FAYETTEVILLE PUBLIC WORKS COMMISSION

Bid Addendum

Bid Title : Big Rockfish Creek Outfall Contract II

Addendum Number: 3

SS-3 - TYPICAL TRENCH BOTTOM AND BACKFILL DETAIL FOR SDR 26 AND C900 PVC PIPE (SANITARY SEWER)

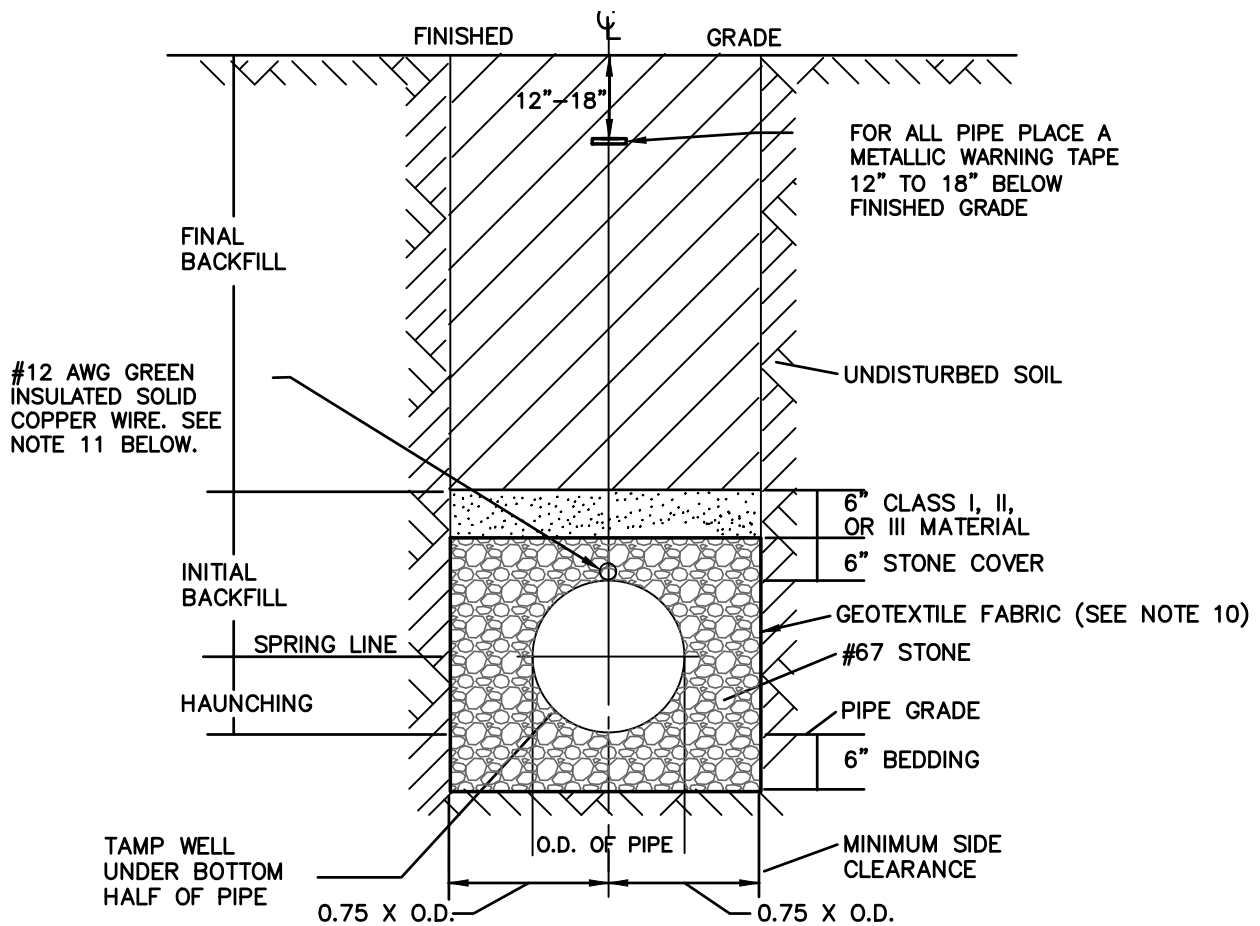
- M1. A new Bid Form has been provided and attached to answer Q1, Q5 and Q7 below (updates to include pipe quantity, hydrostatic testing revisions, stream impact updates and pipe material requirements for 8" and 12" gravity sewer mains).
- M2. Detail SS-3=Typical Trench Bottom and Backfill Detail for SDR 26 and C900 PVC Pipe shall be included as part of the details included in the issued for bid drawings. The inclusion of this detail provides an answer to Q6 as noted below.
- M3. Pressure class requirements for restrained joint for large diameter pipe including 18" and 24" as indicated in Section 01000, Item 85. E is revised from Pressure Class 350 to Pressure Class 250.

Q6. Can you tell me if select backfill will be required above the pipe or if the native material will be acceptable? Special Provision 85 calls out a detail SS-3 that is not shown on the plans, so we are unsure of the backfill material above the pipe.

A6. Final backfill material shall be suitable native material. Detail SS-3 was inadvertently left off the issued for bid drawings, but it has been included as part of this addendum. See M2 above.

3. FINAL BACKFILL MATERIAL SHALL BE SUITABLE NATIVE MATERIAL.
4. BACKFILL SHALL BE TAMPED IN 6" LIFTS IN TRAFFIC AREAS, 12" IN NON-TRAFFIC AREAS.
5. TOTAL TRENCH WIDTH SHALL BE A MINIMUM OF 1.5XO.D. OF PIPE.
